Product Change Notification

PCN #:	AM20251104-1
Issue Date:	November 4 th , 2025
Products series affected:	AMESR-277LPZ series
Product list:	AMESR-2.5S277LPZ
Effective Date:	All part numbers from the above product list shipping from Aimtec as of the issue date of this PCN.
Description of change:	All part numbers listed in the above product list from the AMESR-277LPZ series have their efficiency, input current, voltage accuracy, line regulation, no-load power consumption, typical application circuit, EMC recommended circuit and dimensions updated as per the details provided in the following ANNEX 1.
Reason for change:	This change has been implemented due to the EOL of critical raw materials.
Customer Impact:	Certain customers may be impacted by these changes in the specifications. Aimtec recommends reviewing the datasheet and testing samples as necessary.
Package Diagram:	N/A

AMESR-277LPZ

AMESR-2.5-5S277LPZ

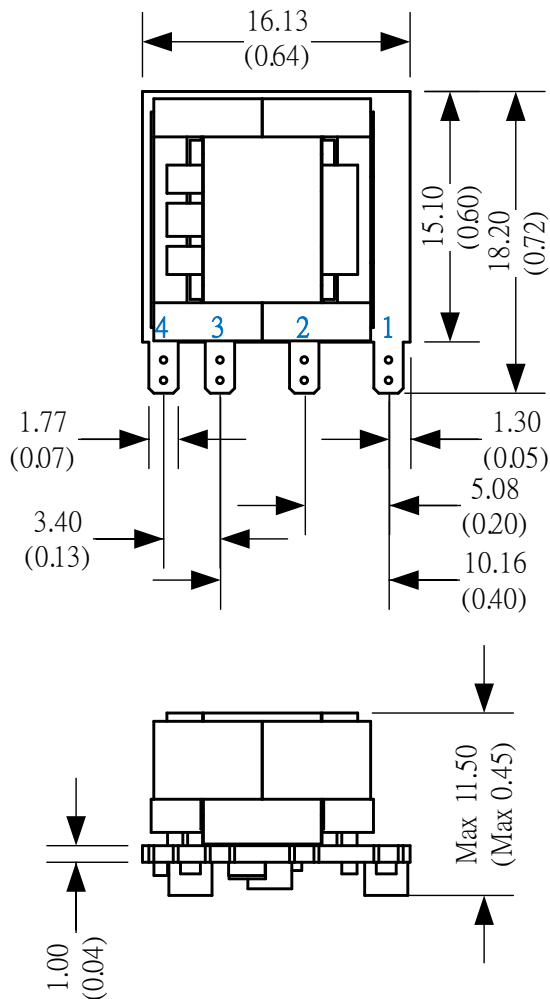
Parameter	Updated AMESR-2.5S277LPZ	OLD AMESR-2.5S277LPZ
Efficiency	68% typ.	67% typ.
Input current	100mA max.	60mA max.
Voltage accuracy	10~100% load: $\pm 5\%$ typ. $\pm 6\%$ max.	10~100% load: $-7/+5\%$ max.
Line regulation	full load: $\pm 1.5\%$ typ.	full load: $\pm 2.5\%$ typ.
No-load power consumption	230VAC: 0.1W typ. 0.15W max.	230VAC: 0.1W typ. 0.3W max.
Typical application circuit	C1:15 μ F/450V C2: 680 μ F/10V	C1:22 μ F/450V C2: 680 μ F/16V
EMC recommended circuit	C1:15 μ F/450V C2: 680 μ F/10V	C1:22 μ F/450V C2: 680 μ F/16V
Dimensions	AMESR-2.5-5S277LPZ  Unit: mm(inch) General tolerance: $\pm 1.00(\pm 0.04)$ Pin diameter tolerance: $\pm 0.10 (\pm 0.004)$	AMESR-2.5-5S277LPZ  Unit: mm(inch) General tolerance: $\pm 0.50(\pm 0.02)$ Pin diameter tolerance: $\pm 0.10 (\pm 0.004)$

General tolerance: $\pm 1.00 (\pm 0.04)$
